County of San Diego
Planning & Development Services
BUILDING DIVISION

ACCESSIBILITY CORRECTION LIST

Multifamily Housing

Public Telephones

CBC FIGURE 11A-1H(b) – ALCOVE MANEUVERING SPACE

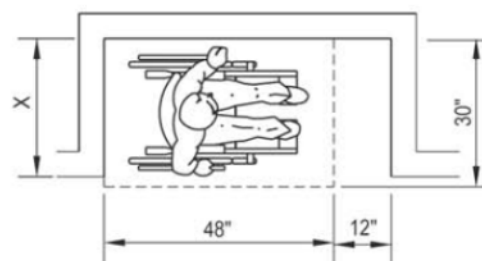
Exception: At accessible telephones located within alcoves, dimension clear floor/ground space per CBC Figure 11A-1H(b)
- Allowing forward or parallel approach
- One full unobstructed side adjoining another wheelchair clear floor/ground space

NOTE : IF X > 24 INCHES, THEN AN ADDITIONAL MANEUVERING CLEARANCE OF 6 INCHES SHALL BE PROVIDED AS SHOWN.

NOTE : IF X > 15 INCHES, THEN AN ADDITIONAL MANEUVERING CLEARANCE OF 12 INCHES SHALL BE PROVIDED AS SHOWN.

CBC FIGURE 11A-11B – TELEPHONE MOUNTING HEIGHTS AND CLEARANCES

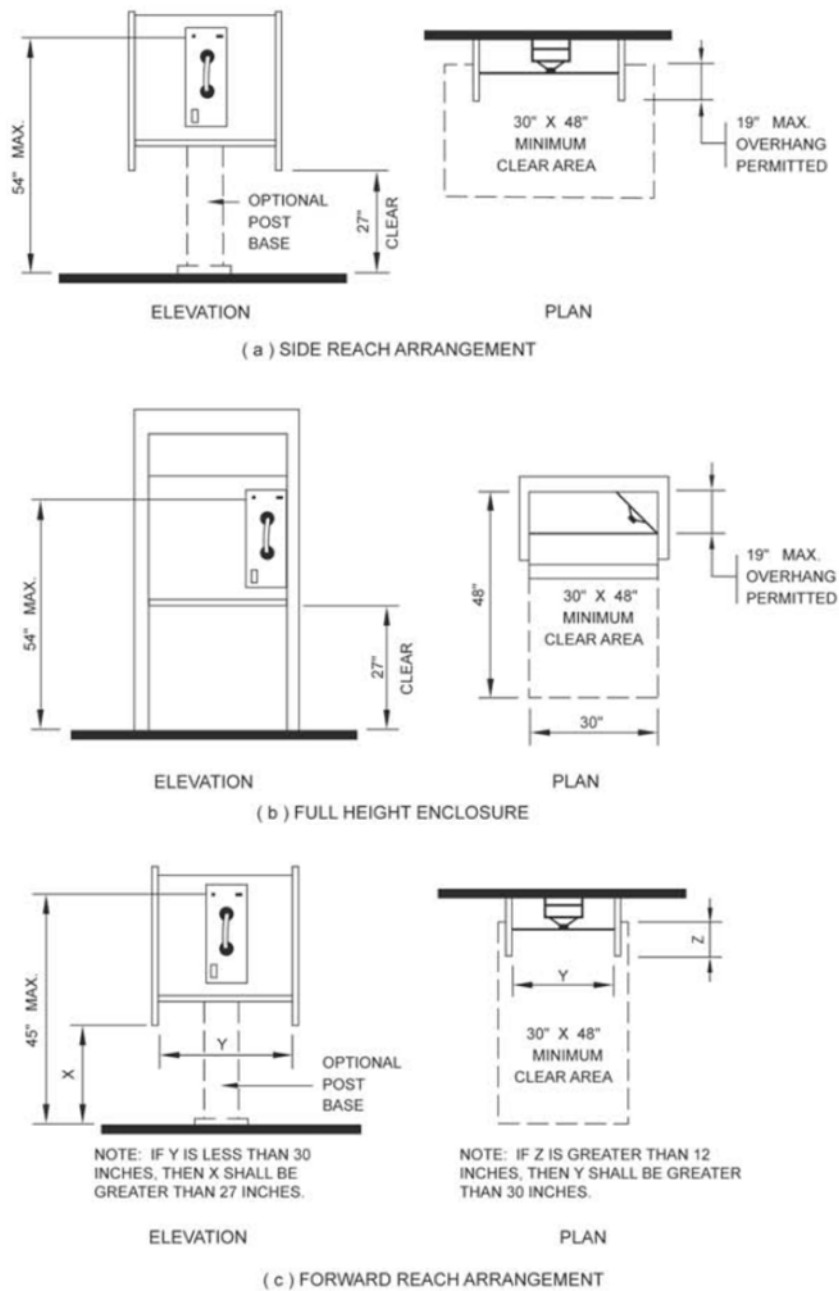
- Minimum 30 inches by 48 inches per CBC Figure 11A-11B

- Where only forward approach allowed, per CBC Figure 11A-11B(c)
- Where parallel approach allowed, per CBC Figure 11A-11B(a)
- Where telephone mounted in corner requiring wheelchair users to reach diagonally, per CBC Figure 11A-11B(b)

- Where only forward approach allowed, per CBC Figure 11A-11B(c)
- Where parallel approach allowed, per CBC Figure 11A-11B(a)
- Where full-height enclosure proposed, per CBC Figure 11A-11B(b)
